November 27, 2023

**RE: NM Beef Jerky– Parking Lot
Grading and Drainage Plans
Engineer's Stamp Date: 11/15/23
Hydrology File: J14D185**

NEW MEXICO BEEF JERKY
OVERFLOW PARKING
ALBUQUERQUE, NM

PROJECT NO: 23052
DESIGNED BY: RJF
DRAWN BY: JB
CHECKED BY: RJF
DATE: NOVEMBER 2023
SHEET TITLE
GRADING PLAN
SHEET NO:
C-1

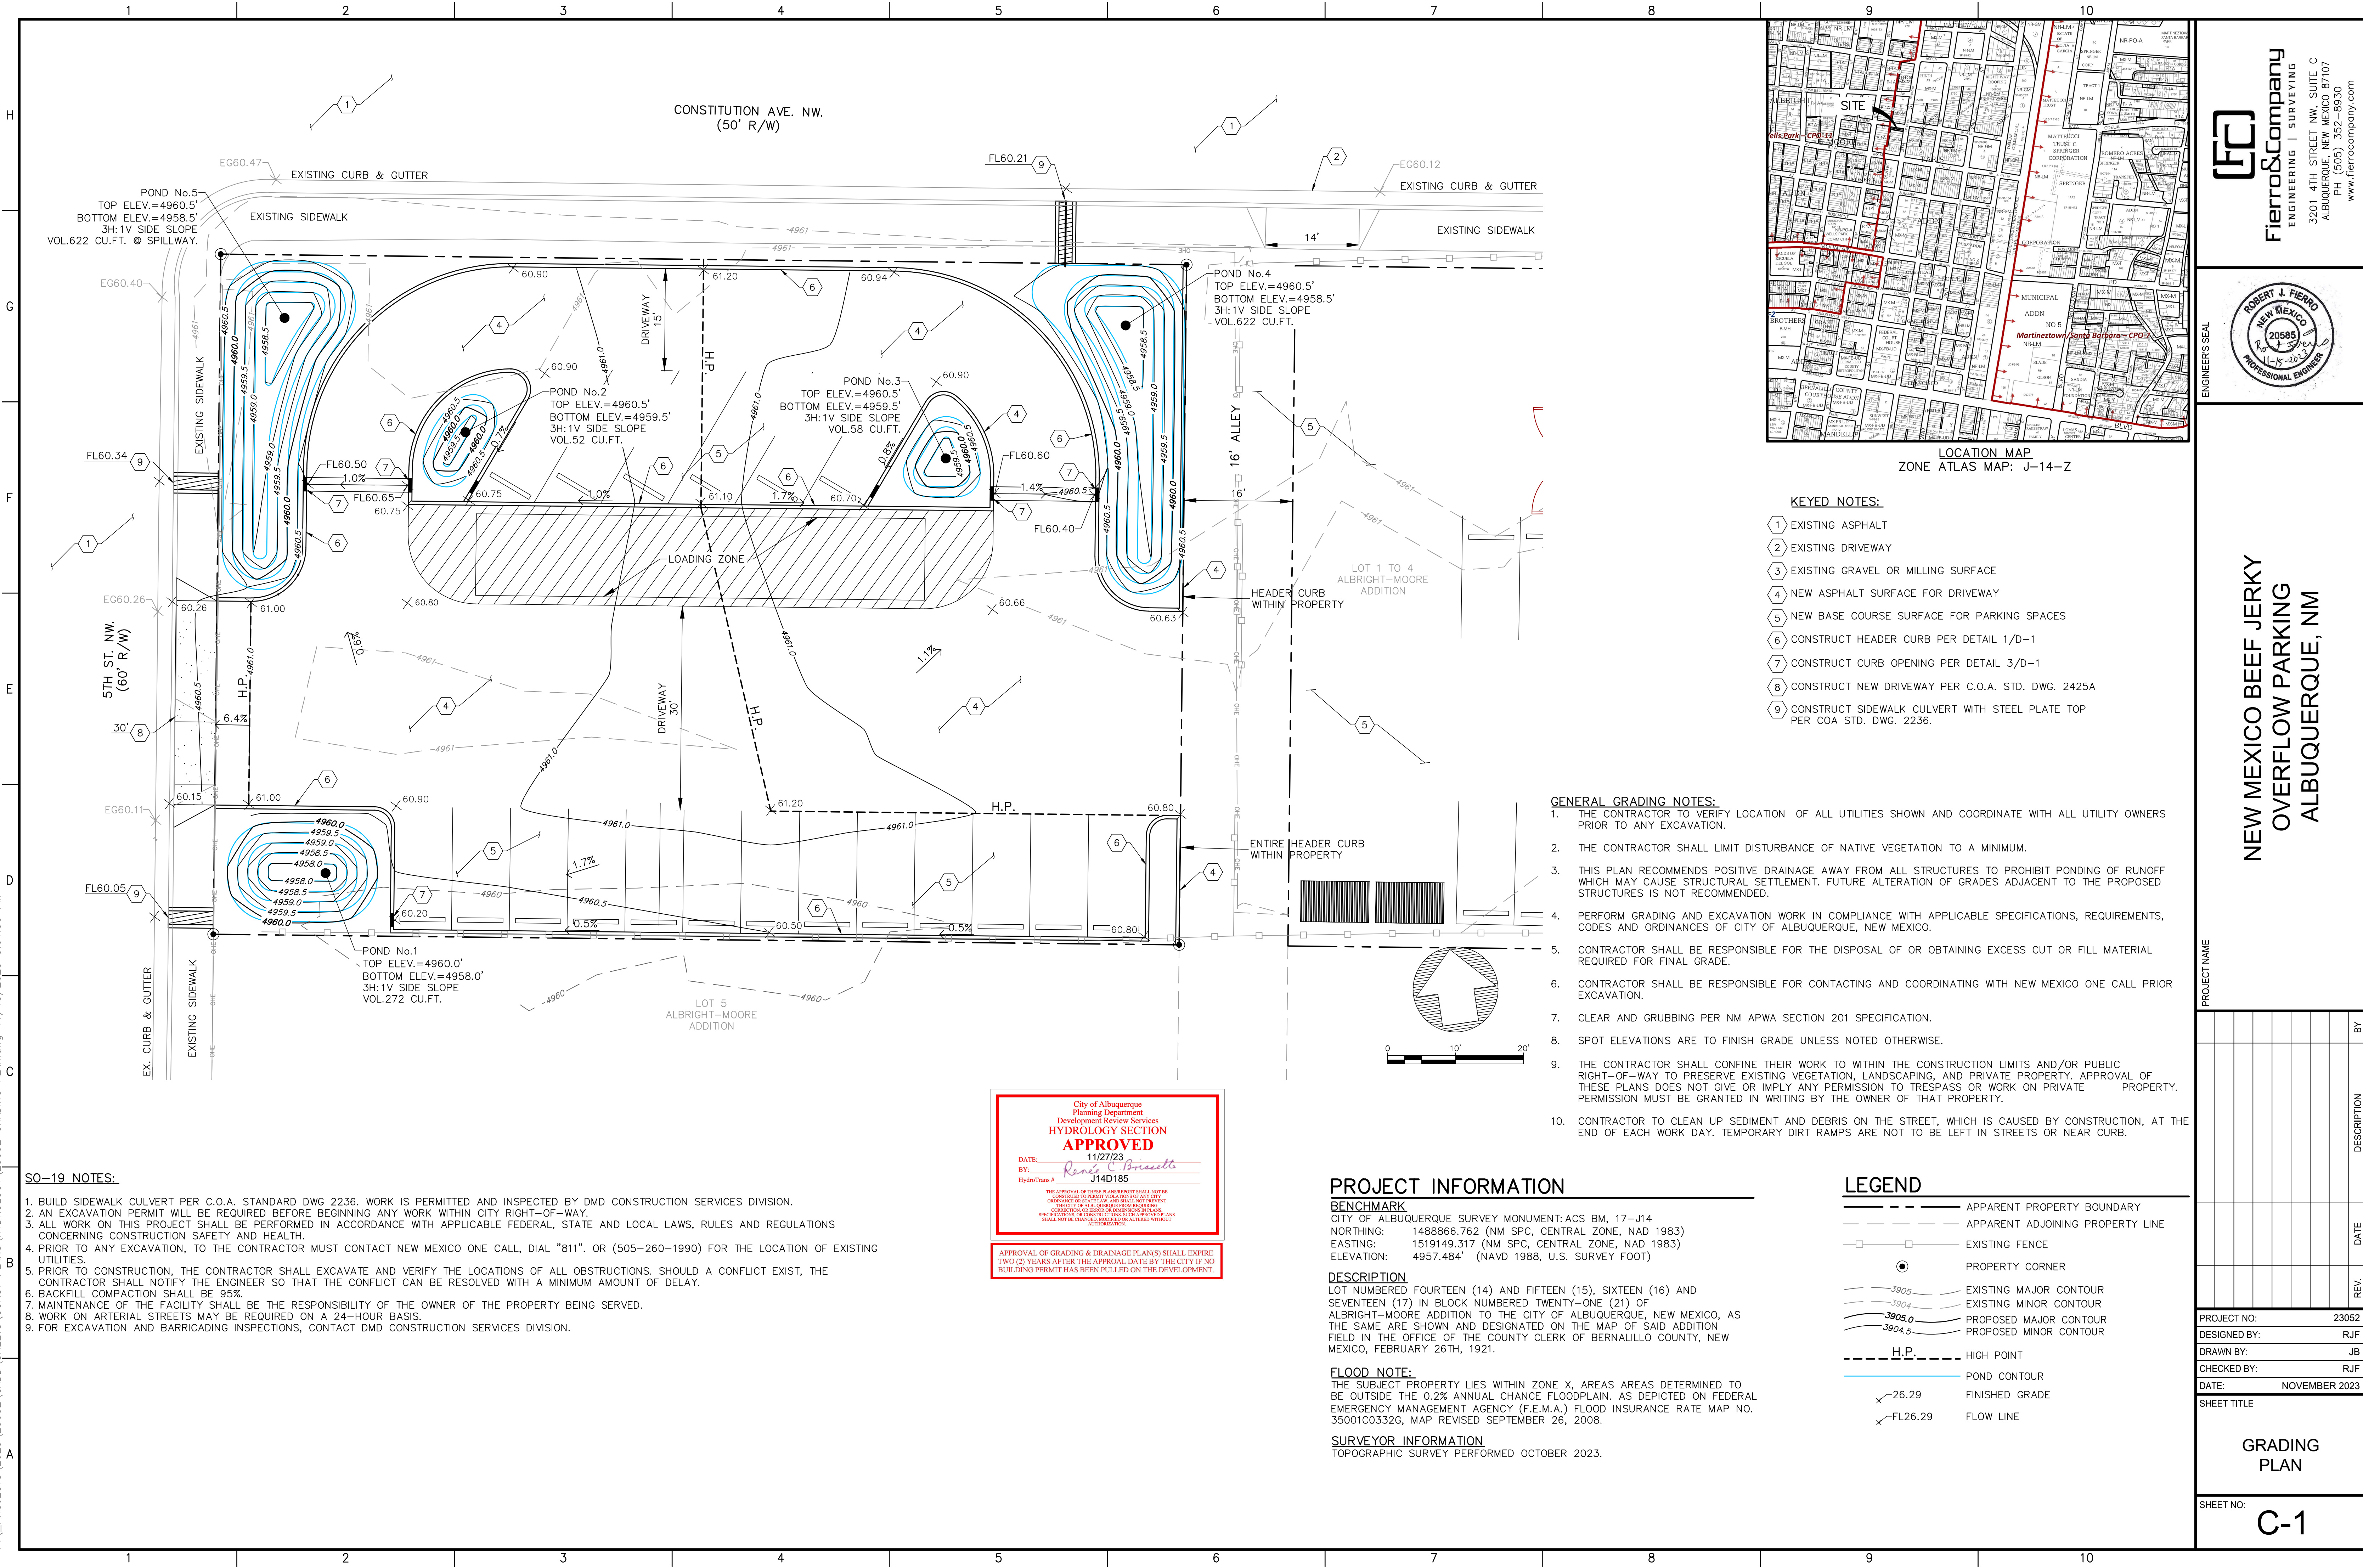
Based upon the information provided in your submittal received 11/19/2023, the Grading & Drainage Plans are approved for Grading Permit, Paving Permit, and SO-19 Permit. Once the grading and paving of the project is complete, please provide an as-built for the City's records since there is no CO attached to the project.

Please provide the executed paper Drainage Covenant (latest revision) printed on one-side only with Exhibit A and a check for **\$25.00** made out to "**Bernalillo County**" for the stormwater quality ponds per Article 6-15(C) of the DPM to Hydrology for review at Plaza de Sol.
